Appl. № 10/708,191
Amdt. dated 6 April 2006
Reply to Office Action of 28 December 2005

Amendments to the Drawings:

REMARKS/ARGUMENTS

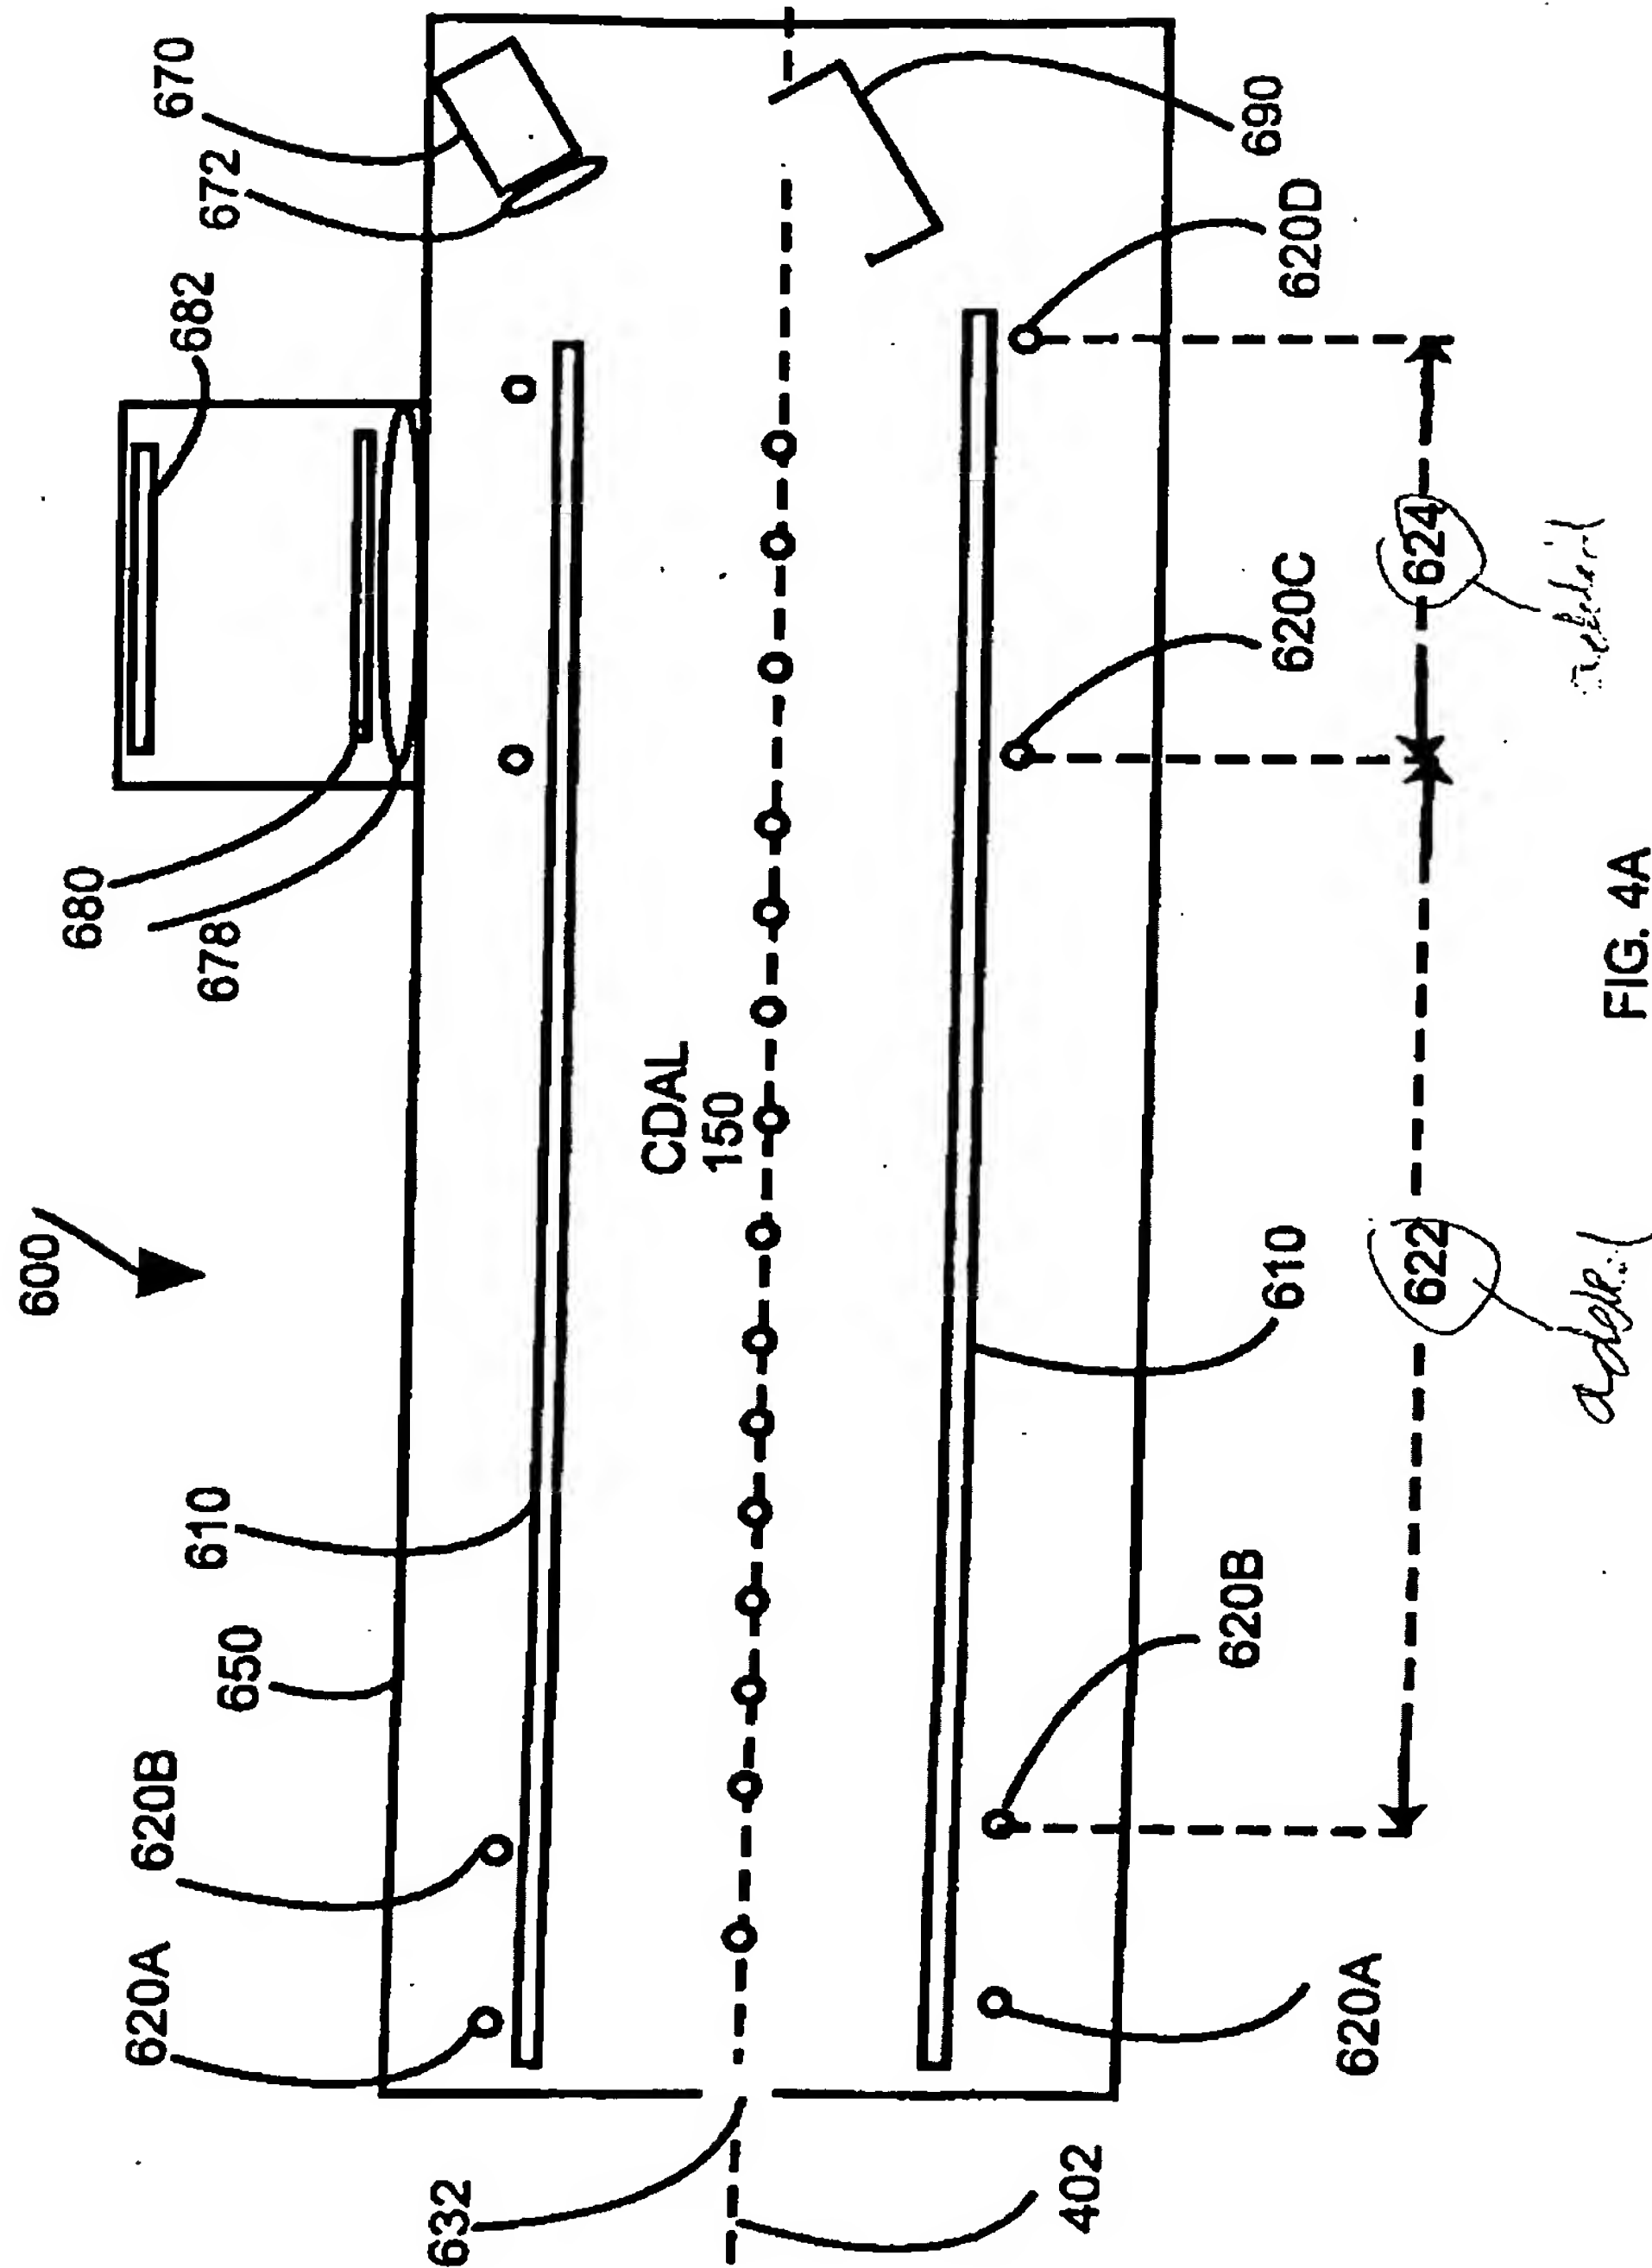
The attached Replacement Sheet showing FIG 4A is amended to illustrate the elements referred to in the specification as "holding region 622" and "measurement region 624" respectively.

Paragraphs [0060] and [0061] reference "holding region 622" and "measurement region 624" in Figure 4A but these regions are not found in the referenced drawing. Figure 4A has been amended to show the two regions referred to in the specification.

FIG. 4B

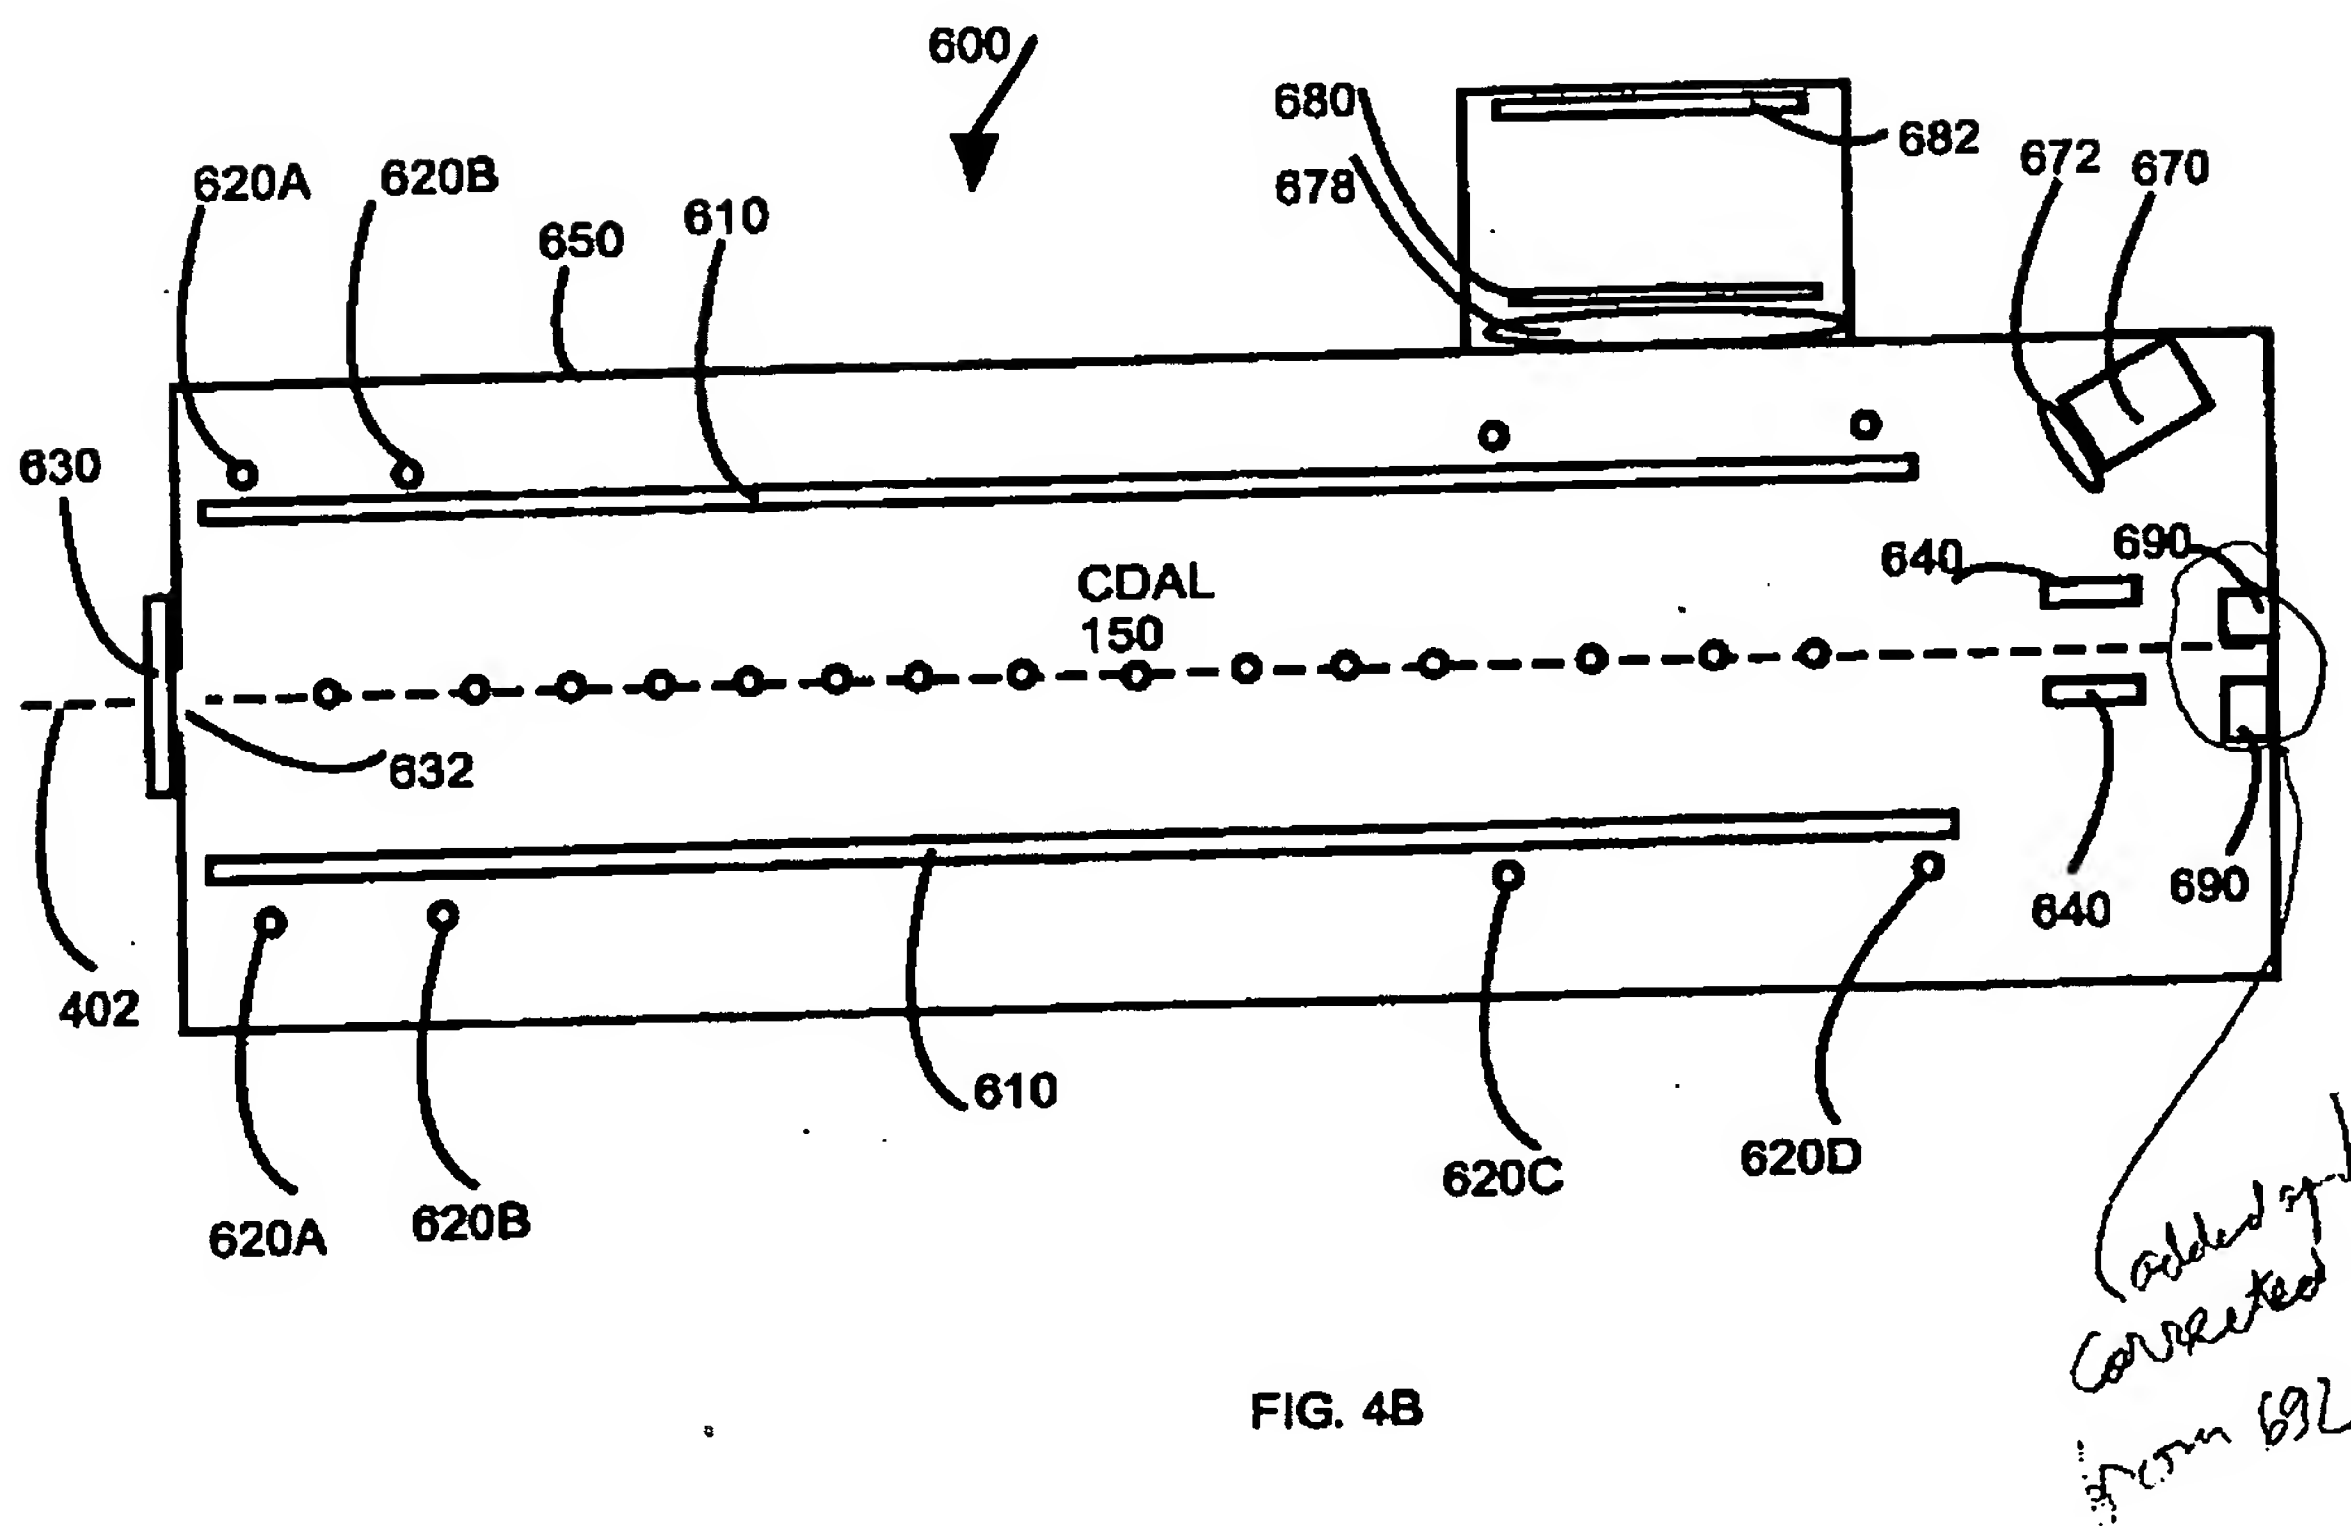
The attached Replacement Sheet showing FIG 4B is amended to designate the elements referred to in the specification as "two receptacles 690" from the incorrect "692".

Paragraph [0063] references "two receptacles 690" in figure 4B but these receptacles are not illustrated in figure 4B. Figure 4B has been modified to show the two receptacles. They were in correctly referenced as "692".

Figure 4B displays reference number 692 but this number is not described in the specification. The figure is amended to correct "692" to "690" which is discussed in the specification.
